# Supplemental

## Office Action Summary

09/877,217

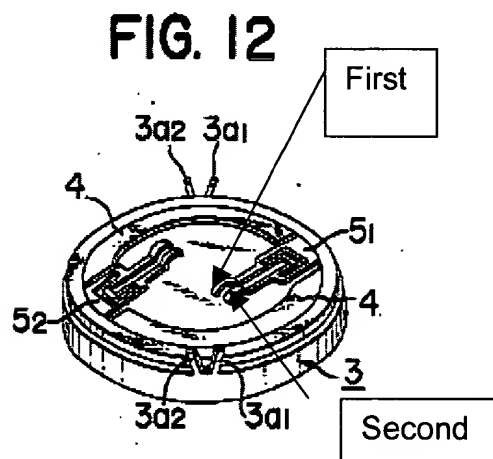
Aoki discloses in figures 1 and 2, a pair of electrode brushes (1) in which each pair of brushes (1) include a first and second separate portions (see figure below) in a sliding contact with the contact electrode part of the commutator at respective sliding contact positions of a different distance from an axis of the rotation of the shaft (6) in order to reduce undesired noise by having a stable contact to between he brush and the commutator.
